# Access Compliance Report

## Public Rights-of-Way

Intersection ID: 5967	Main Street: TRYON_ST	Cross Street: MCCULLOUGH_DR	Location: S
ADA ID: 39C3D99091C7	Ramp Type: BlendTrans2	Initial Pass/Fail: Pass	Overall Compliance: No
Severity Score: 5			
Codes/Mitigation Info/Possible Solution		Field Measurements/Component Compliance

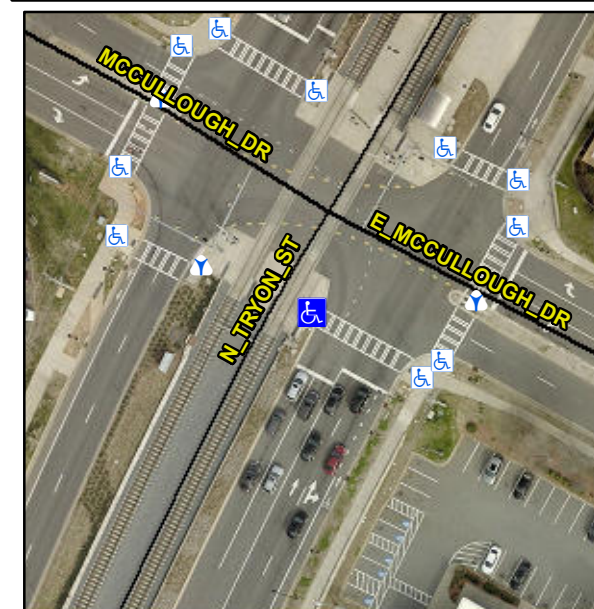
**Remove & Replace Curb Ramp With Two New Directional Ramps or Equivalent.**

**R304.2.3, R305.2**

Compliance	Description	Data	Compliance	Description	Data
N/A	Ramp Length (in)	89.0	Yes	BlendTrans Slope (%)	0.7
Yes	Ramp Width (in)	121.0	Yes	BlendTrans XSlope (%)	0.9
Yes	Flare Type	Curbed_NoWalkSurface	No	Flare Type	Curbed_WithWalkSurface
N/A	Flare Slope LT (%)	N/A	N/A	Flare Slope RT (%)	N/A
N/A	Flare Traversable LT?	No	N/A	Flare Traversable RT?	No
N/A	Landing Length (in)	N/A	Yes	DWS Provided?	Yes
N/A	Landing Width (in)	N/A	Yes	DWS Contrast?	Yes
N/A	Landing Slope (%)	N/A	Yes	DWS Length (in)	24.0
N/A	Landing X Slope (%)	N/A	Yes	DWS Full Width?	Yes
N/A	Landing Curb? (Y/N)	No	No	DWS Offset (in)	2.5
N/A	Shared Landing?	No			
Yes	Gutter Ponding?	No	Yes	Gutter Slope (%)	2.5
Yes	Gutter Lip Ht (in)	0.25	Yes	Gutter X Slope (%)	1.8
N/A	Painted X Walk1?	Yes	N/A	Painted X Walk2?	N/A
	X Walk 1 Direction	To SE		X Walk 2 Direction	N/A
	X Walk 1 Width (in)	106.0		X Walk 2 Width (in)	N/A
	X Walk 1 Slope (%)	2.0		X Walk 2 Slope (%)	N/A
